Cuckoo's Nest, Greenhills Road, Kilnamanagh, Dublin 24

CFI Submission

Ref No. SD22A/0285

Please find landscape response to items (2 and 3a,3b,3c)

-  Site Outline
-  Approximate outline of Tymon Park

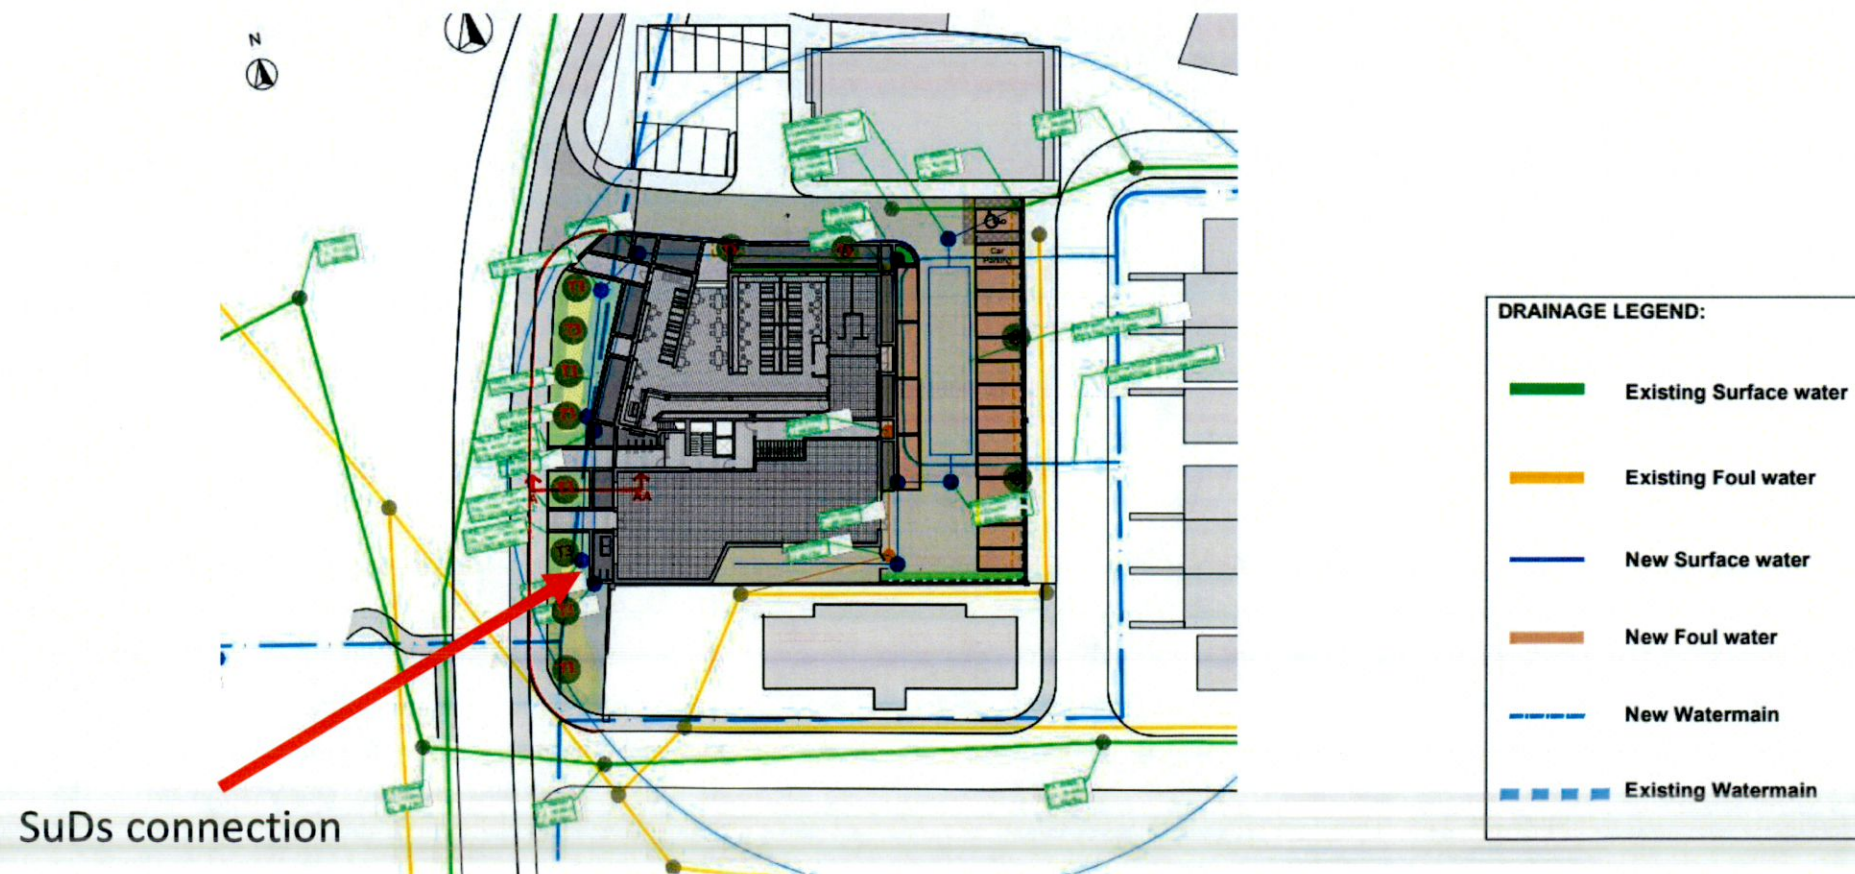
The applicant is requested to provide greater detail about proposals to mitigate the absence of public open space provision on site. In this regard the applicant is requested to liaise with the Public Realm Department and agree suitable upgrades to Tymon Park that would benefit the future occupants of the proposed development.

We had a meeting and several consultations with the public realm/ parks department in relation to the suitable upgrades for Tymon park that would benefit the future occupants of the proposed development. We are in agreement that a contribution is to be made for the suitable upgrade to Tymon Park. The value calculation of these works is ongoing between SDCC and ourselves. Please see consulting planner Armstrong Fenton's response.

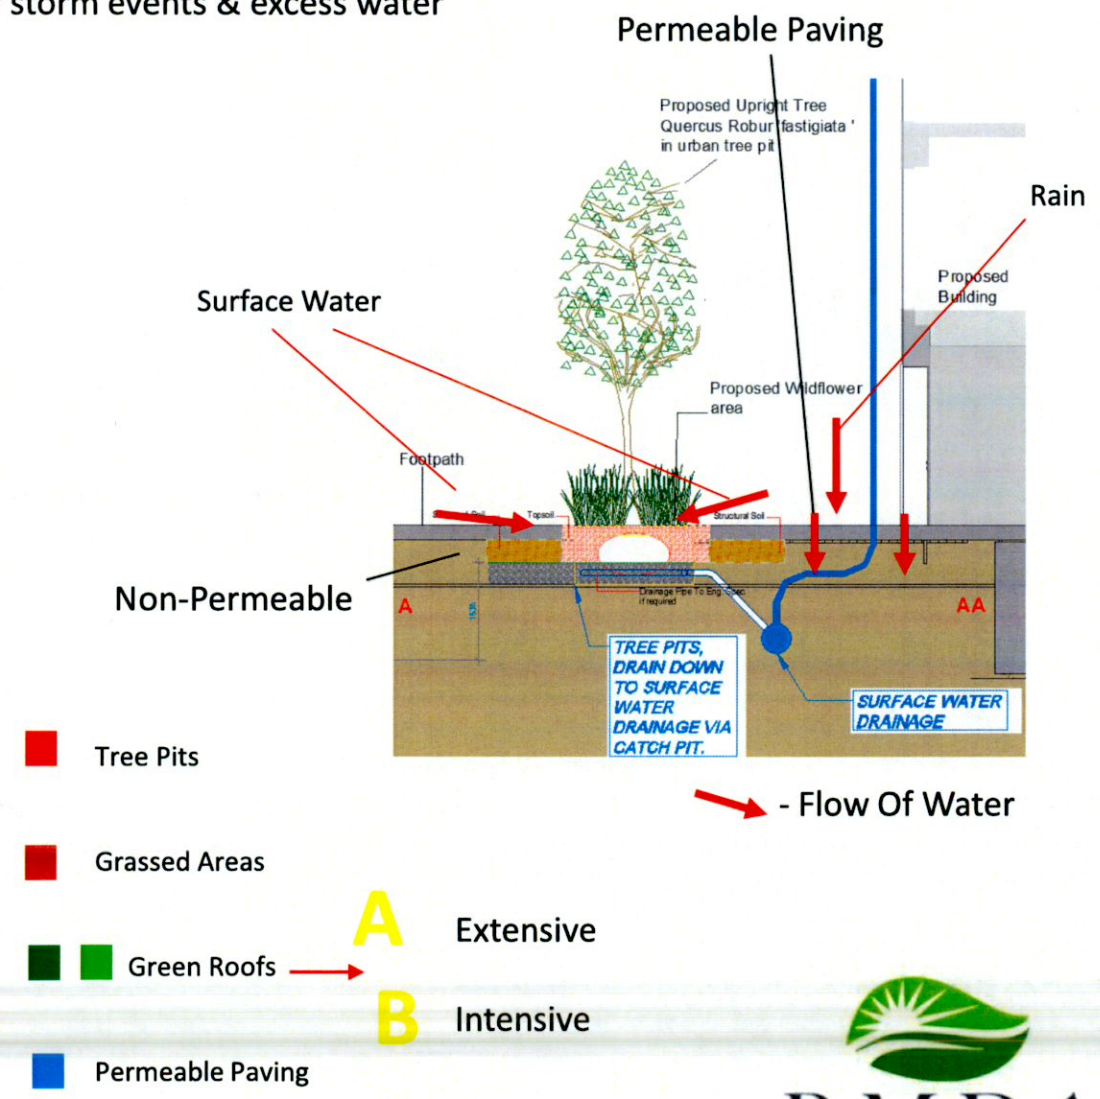
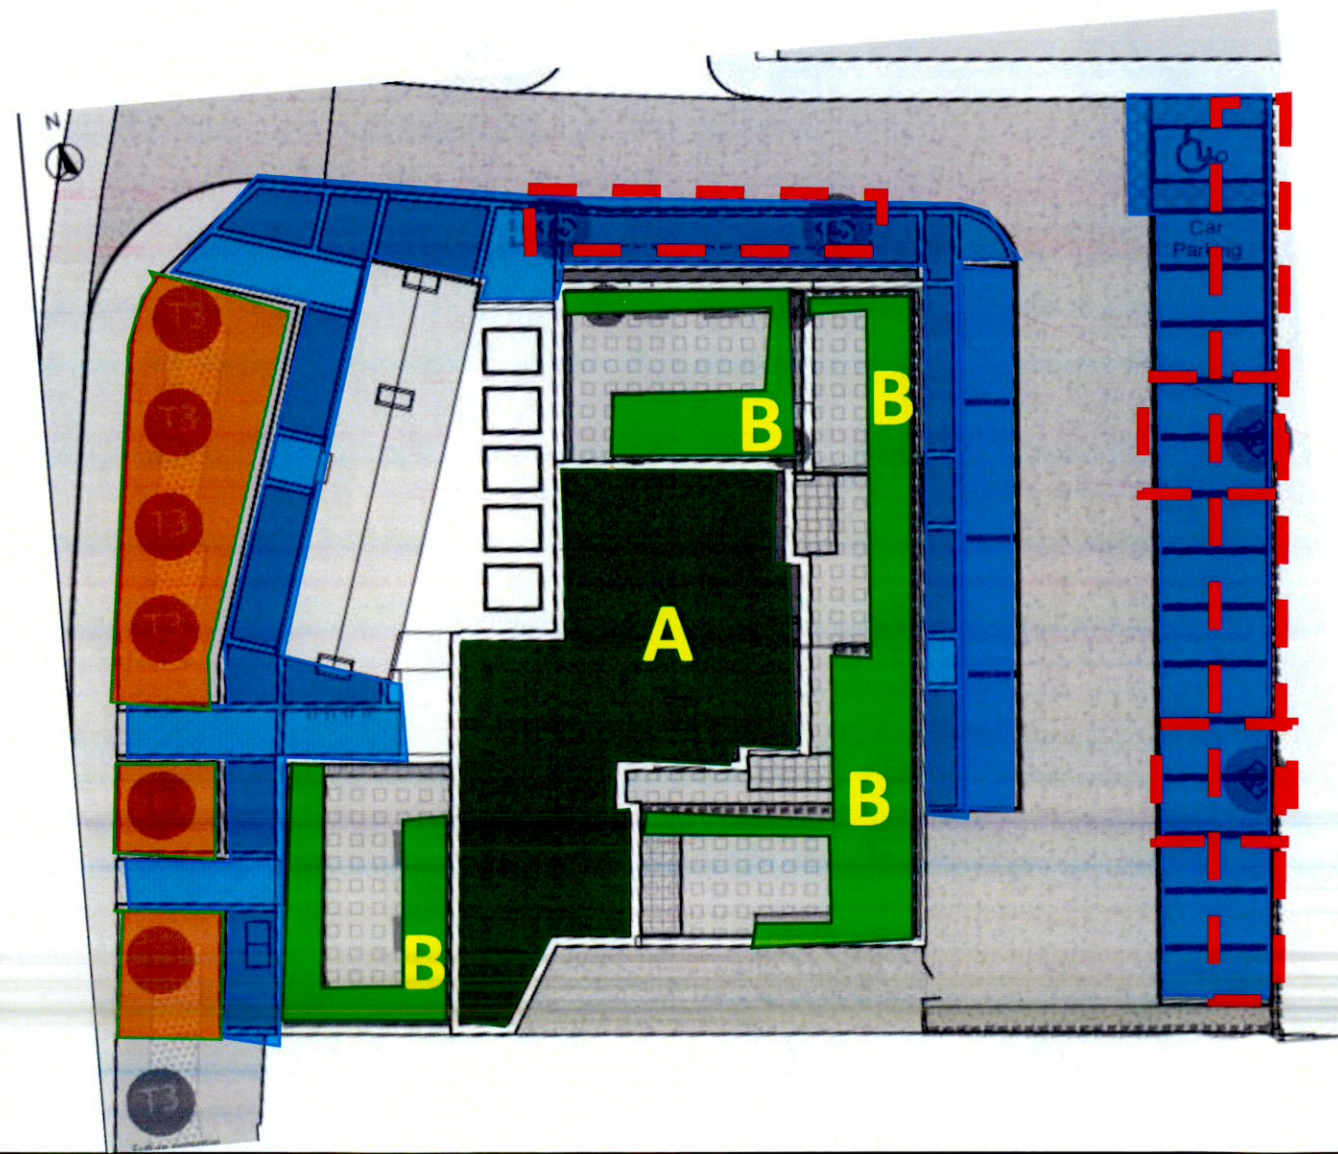
i. Demonstrate the treatment train, biodiversity value and amenity value of the SUDS proposals for the catchment in the residential areas.

B (i) – The Suds strategy has been developed and designed by the consulting Engineers, RMDA have suggested landscape interventions, which the consulting Engineers have incorporated into the natural Suds strategy. All natural Suds interventions are interconnected to provide for a total volume. Therefore, fragmentation would affect the ability of the natural Suds train to clean and store temporarily the surface run off. This cannot happen, and is therefore connected, as may be seen from the Engineers drawings and RMDA graphic

The Suds train is not fragmented but provides a total so it may offset the quantum that a tank has to deal with. Notably the water enters the natural Suds train first, thereby cleaning it, which is one of the principal reasons for employing natural Suds details.

The Suds details on site takes water from the immediate area and follows the Suds train thereafter.

The Suds details and the green infrastructure are closely related, the surface water passes through the natural interventions, green roof, tree pits, grass areas and the hydrocarbons are removed. The green infrastructure is required as the first step of the Suds Train, removing impurities and temporarily storing the surface water.

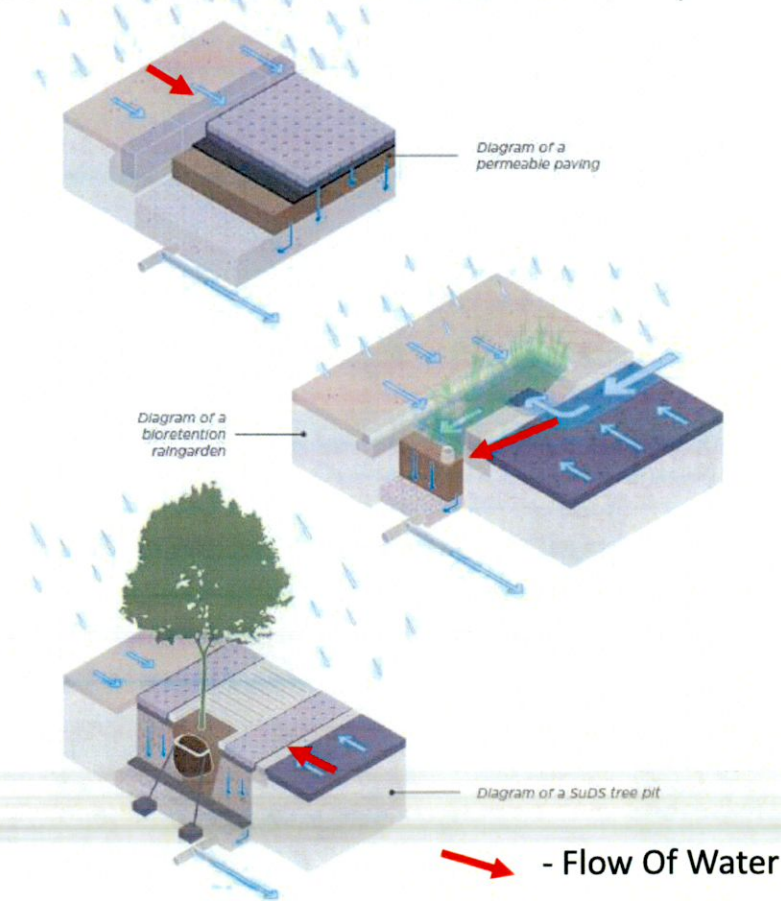
B. iii. The applicant shall show further proposed SuDS features for the development such as green roofs, grass areas, channel rills, swales, permeable paving and other such SuDS and show what attenuation capacity is provided by such SuDS. Bio retention tree pits should be designed so that they enable tree pits to both support healthy tree growth while at the same time to help treat and attenuate water coming from hard landscaping areas.

3 iv. Natural Suds measures should be detailed to remove/ reduce the requirement for underground attenuation tanks in line with the development plan objectives.

B. (iii) - - Please see graphic showing extent of suds features for the development such as Green Roofs, Grass Areas, Permeable Paving, Tree Pits and Planting. Also please see drawings (DWG 1,DWG 3,DWG 4,DWG 5) for the Landscape SuDS details. The tree pits shall have an overflow pipe in cases of storm events & excess water

3 (iv) - Please see Consulting Engineer DWG and Report. Natural SuDS measures have been included throughout the development; these include the green roof, grass areas, permeable paving, tree pits and planting

SDCC SuDS Explanatory, Design and Evaluation Guide

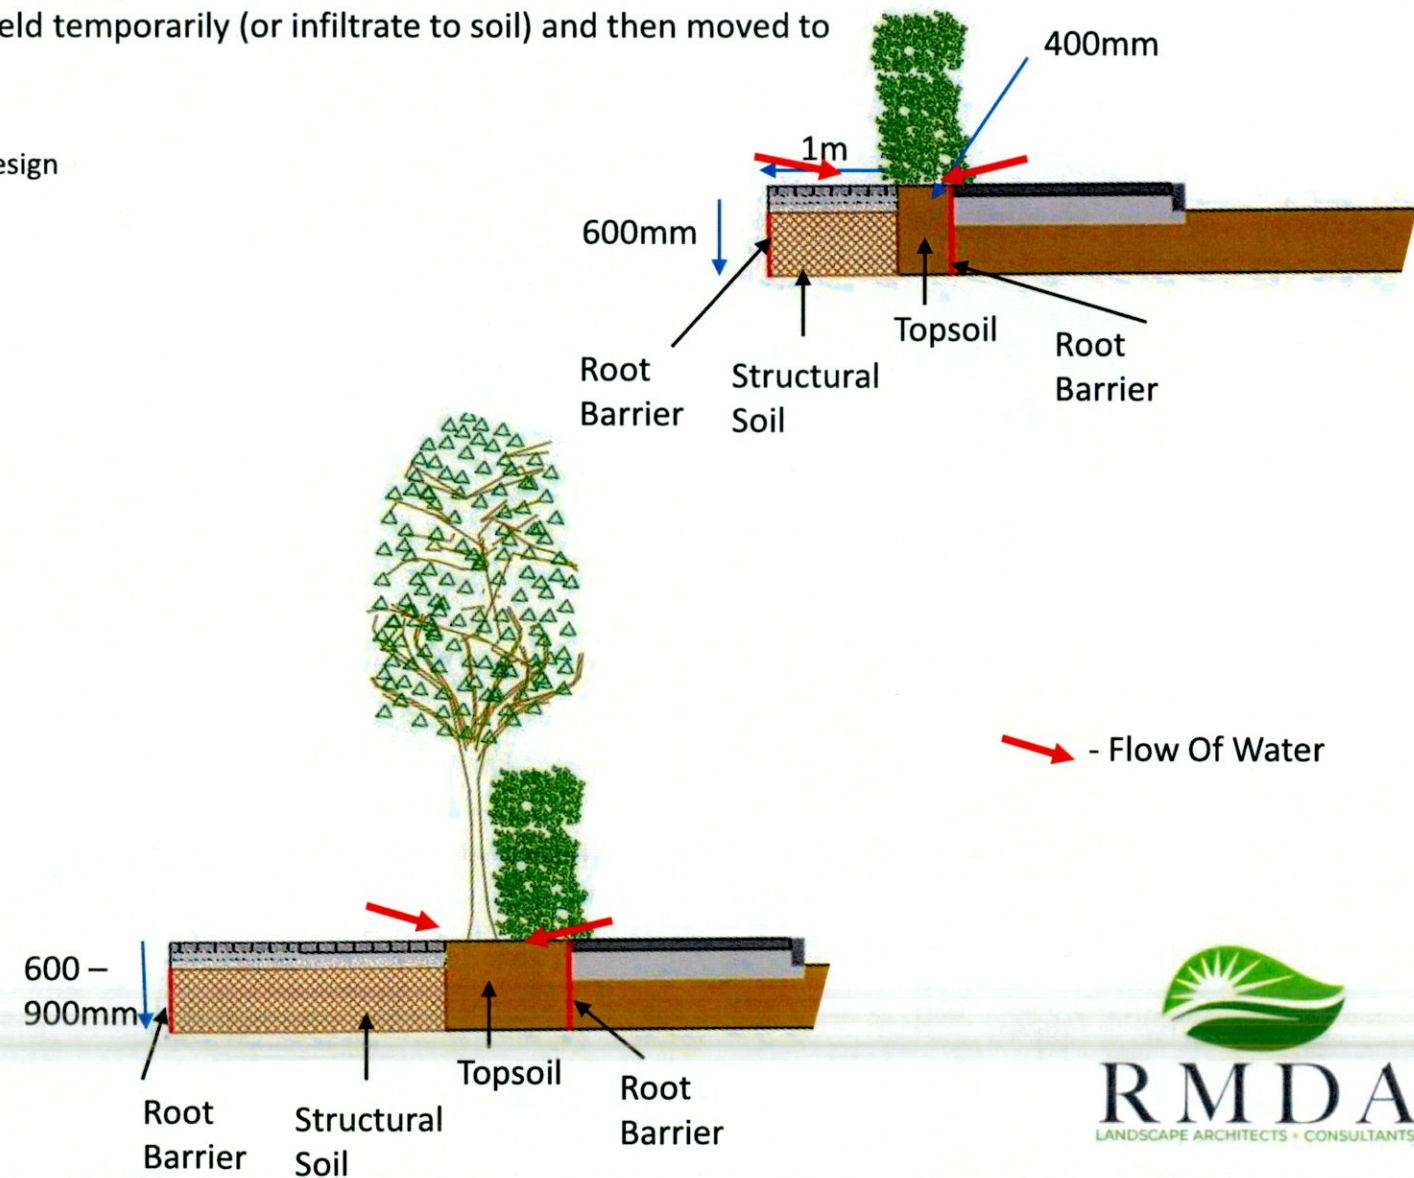
v. Tree Pits to incorporate SuDS bioretention features and sufficient growing medium. SuDS details need to show how the water drains from the road/pavement hard surface into the SuDS tree pit, clearly outlining how SuDS features within the tree pits will function. The applicant is requested to refer to the recently published 'SDCC Sustainable Drainage Explanatory, Design and Evaluation Guide 2022' for acceptable SuDS tree pit details.

3 (v) - The consulting engineer and RMDA have detailed the tree pit with the SuDS function. The water should fall from the road/paths to the tree pit where it shall be held temporarily (or infiltrate to soil) and then moved to the surface water system

We have referred to the 'SDCC Sustainable Drainage Explanatory, Design and Evaluation Guide 2022' in the installation of tree pits

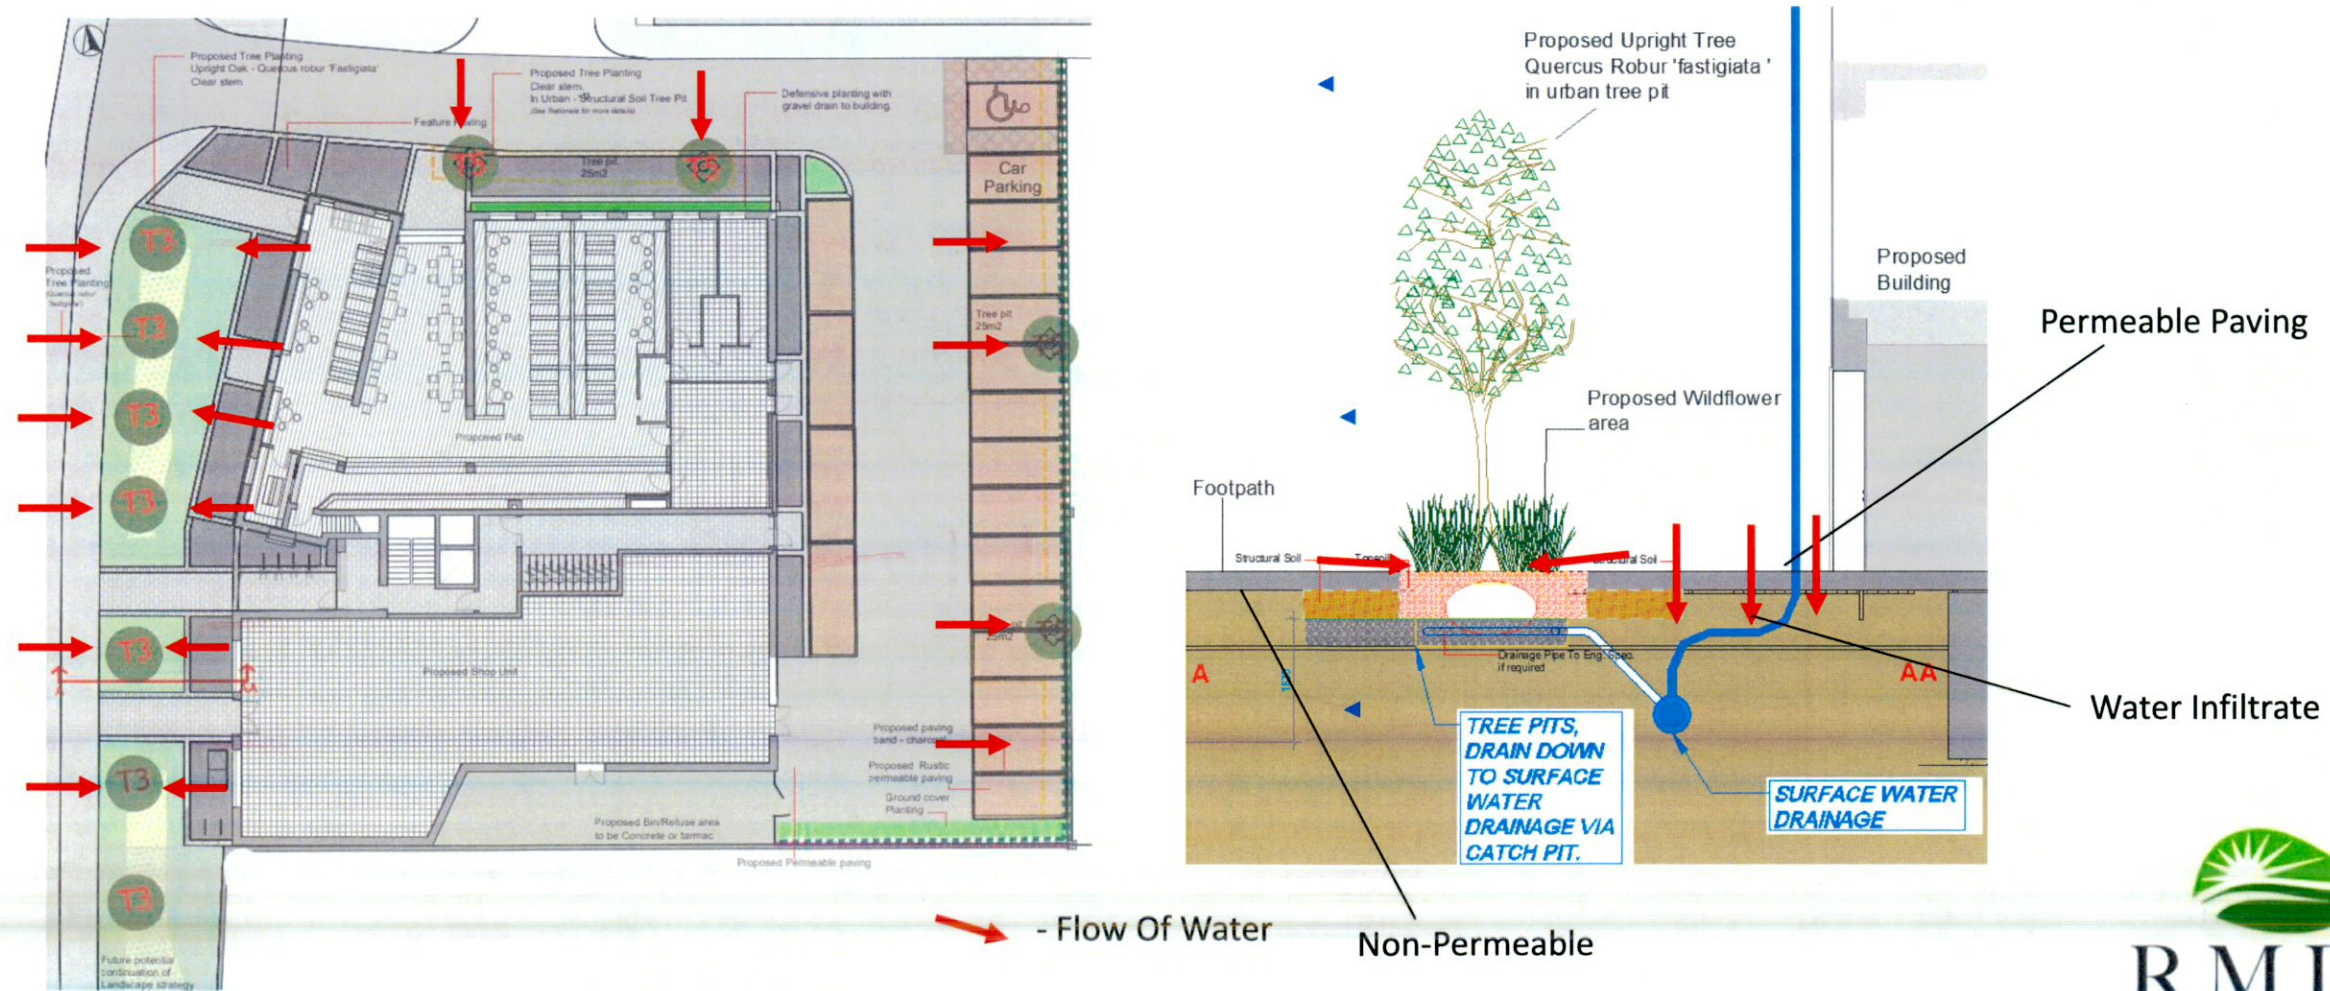
v. Tree Pits to incorporate SuDS bioretention features and sufficient growing medium. SuDS details need to show how the water drains from the road/pavement hard surface into the SUDS tree pit, clearly outlining how SuDS features within the tree pits will function. The applicant is requested to refer to the recently published 'SDCC Sustainable Drainage Explanatory, Design and Evaluation Guide 2022' for acceptable SUDS tree pit details.

(v) - The paving surrounding the tree pits is permeable, the tree pits close to hardcore areas. The tree Pits are to incorporate SuDS bioretention features and sufficient growing medium (16-20 cubic metres). The SuDS details show how the water drains from the road/pavement hard surface into the SUDS tree pit, clearly outlining how SuDS features within the tree pits will function. We have referred to the recently published 'SDCC Sustainable Drainage Explanatory, Design and Evaluation Guide 2022' for acceptable SUDS tree pit details.
